REVISED
ENVIRONMENTAL IMPACT STATEMENT

WESTBURY CONDOMINIUM

November, 1981

FIGURE 4a.

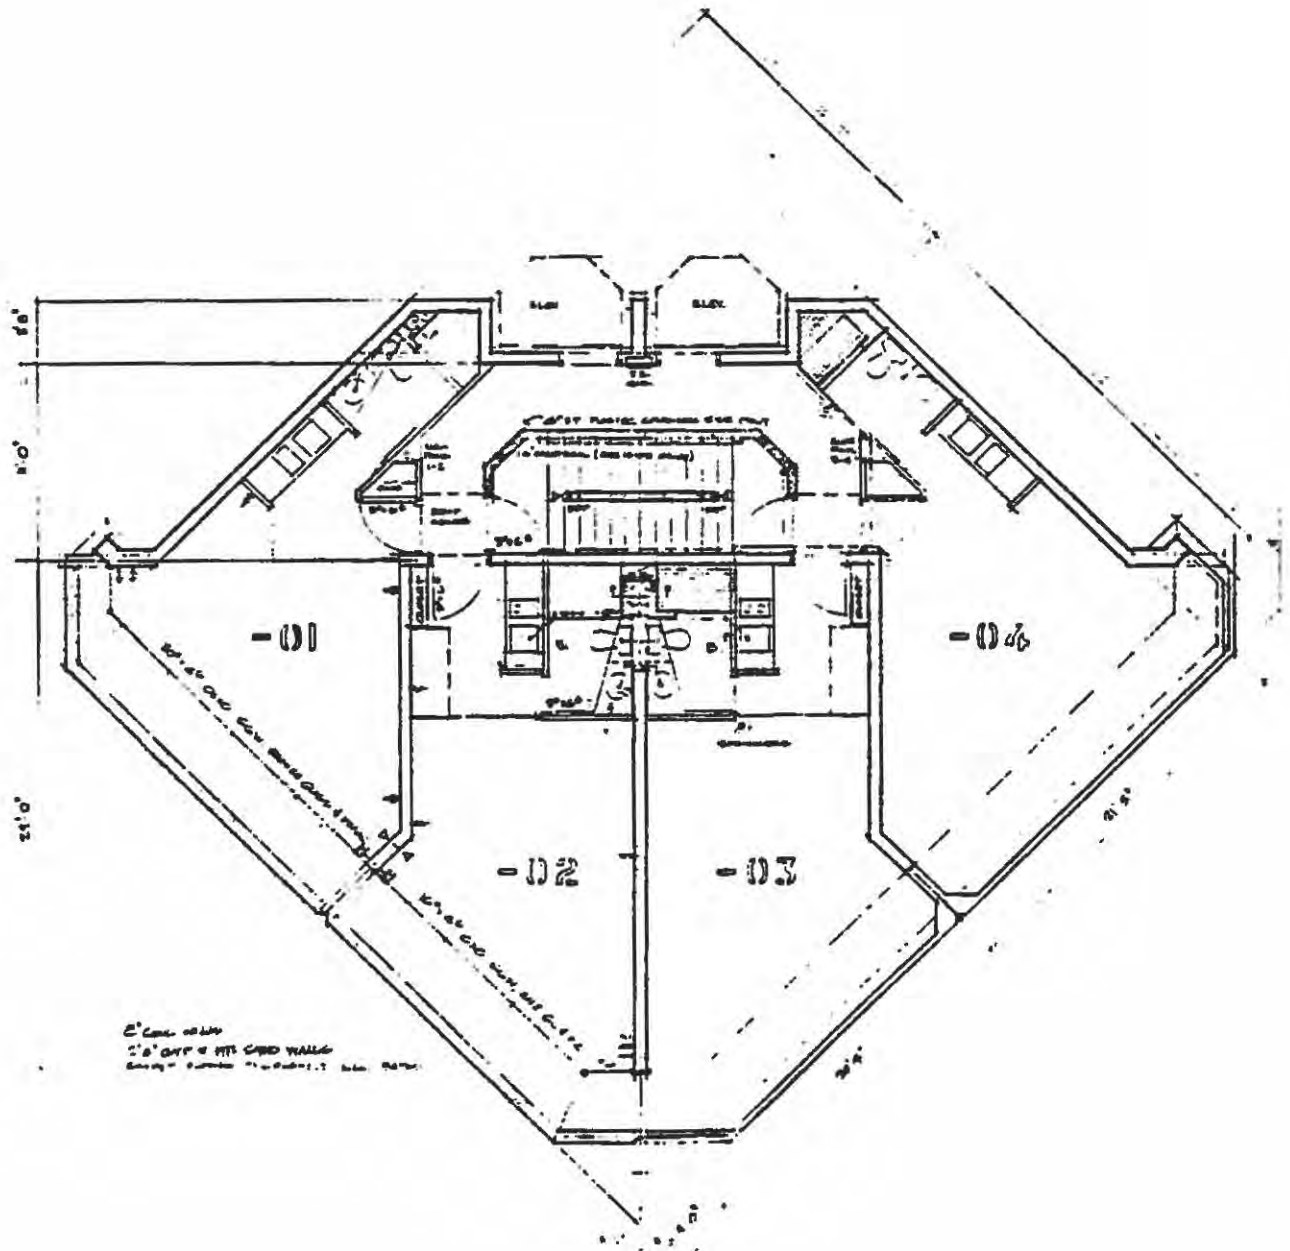
The floor plan and description of the units do not specify kitchen facilities (i.e., sinks). The DEIS should include a more complete description of the apartment units and a floor plan indicating the location of all kitchen facilities.

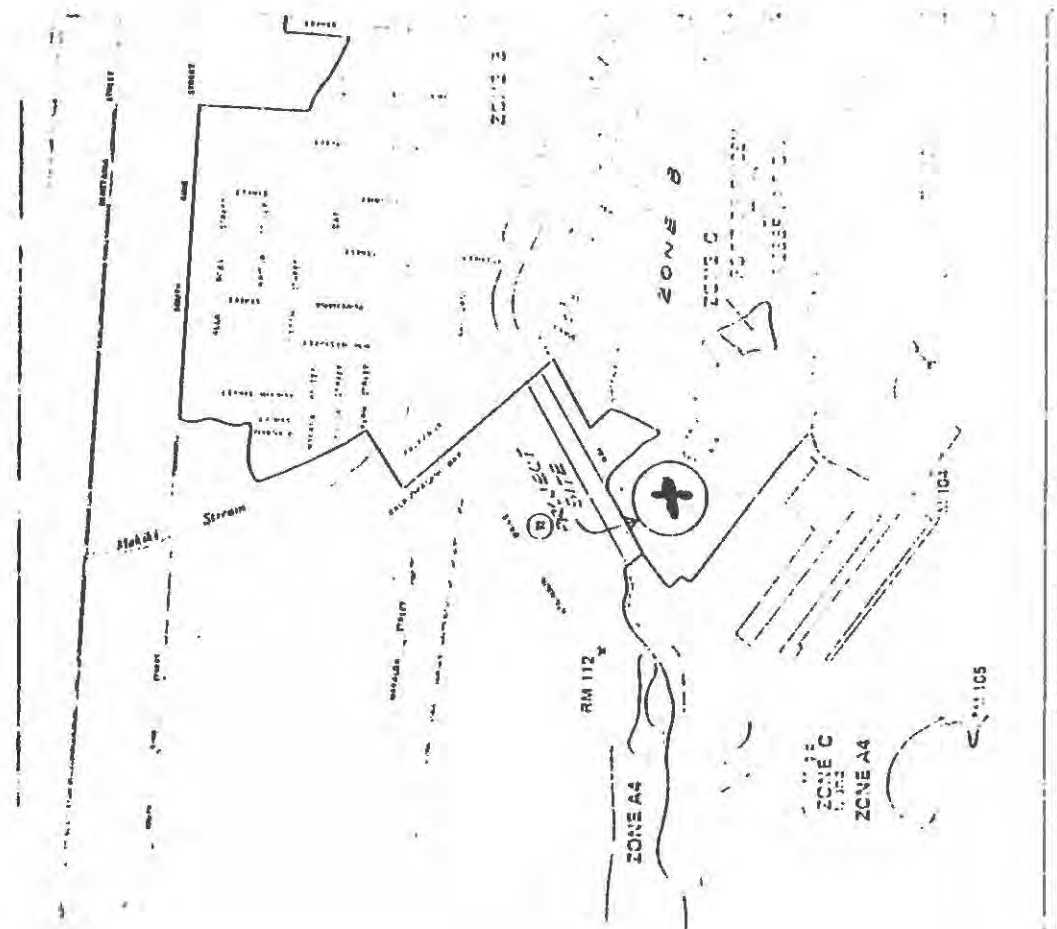
b. Reference EIS text pages 10 and 11 (E. Flood/Tsunami); and Corps letter dated 5 October 1981 to Wil Chee Planning: According to the revisions to the City and County of Honolulu's Flood Insurance Study for Oahu for the Waikiki area, as shown on the updated preliminary Flood Insurance Rate Map (FIRM) (12 November), the proposed condominium is designated an area of 100-year shallow flooding of 2-foot average depth (Zone A). Inclosure 1 is the updated FIRM for the area.

Thank you for your information. The new data from the Flood Insurance Map updates will be included in our Revised EIS. Mahalo!
